37/03-06F 511 Philadelphia Ave

Takoma Park Historic District, 37/03

Address: 511 Philadelphia Ave, Takoma Park Meeting Date: 2/22/2006  
 Resource: Contributing Resource Report Date: 2/15/2006  
 Takoma Park Historic District  
 Applicant: Eric & Jennifer Kilbride Public Notice: 2/8/2006  
 Review: HAWP Tom - condition of window Tax Credit: None  
 Case Number: 37/03-06F Staff: Tania Tully  
 PROPOSAL: window replacement storm does not visibly change

511 PHILADELPHIA AVENUE

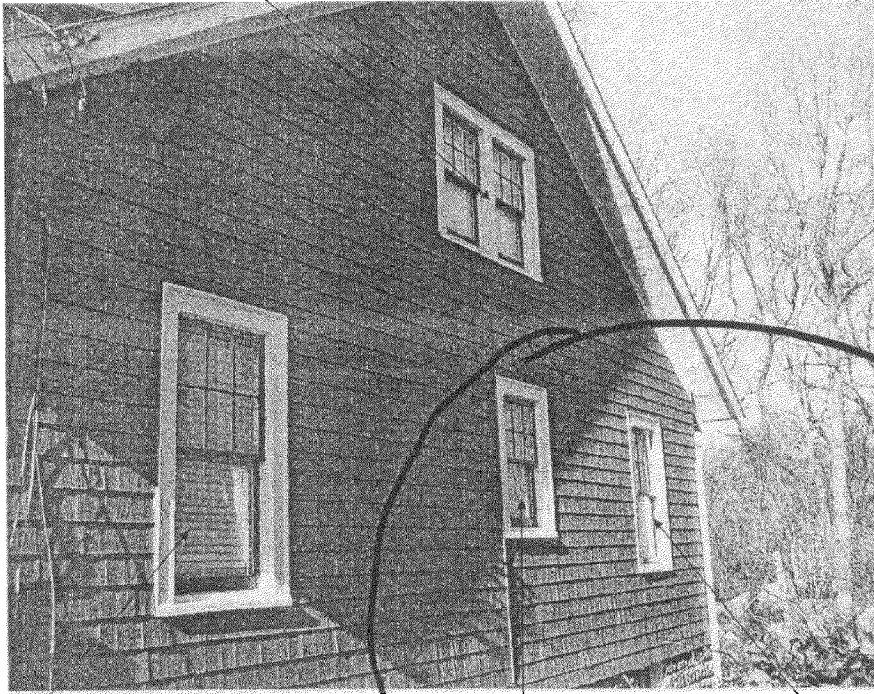
Staff Recommended

Condition  
#1

~~Replace the two windows~~

~~Replace this window~~

Replace this window

Replace this window

Only three windows at the rear of the property - as shown on Circle 20 - plus any others that cannot be viably restored as approved by staff are approved for replacement.

511 PHILADELPHIA AVENUE

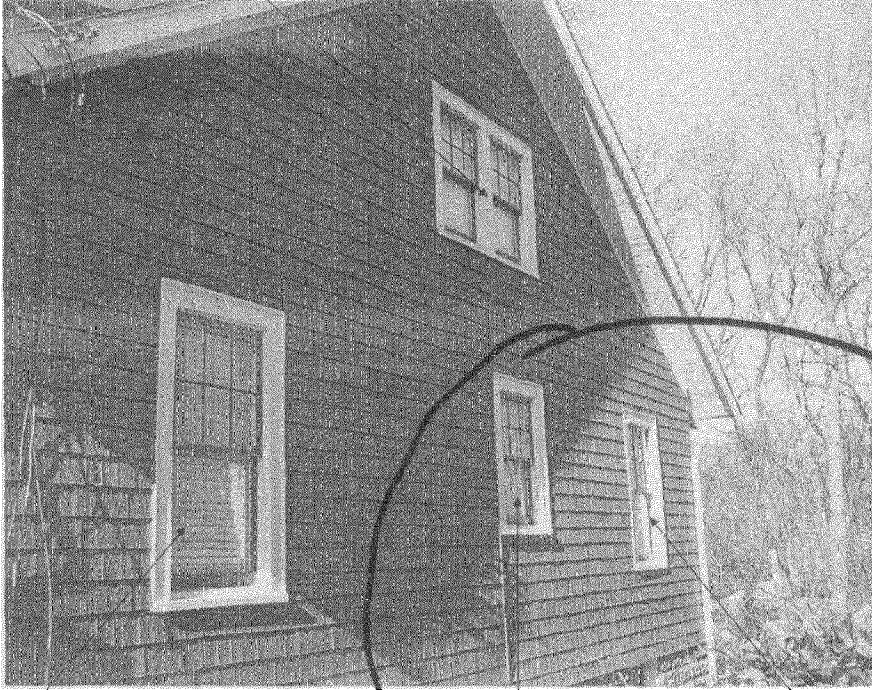
Staff Recommended

Condition  
#1

~~Replace this window~~

~~Replace this window~~
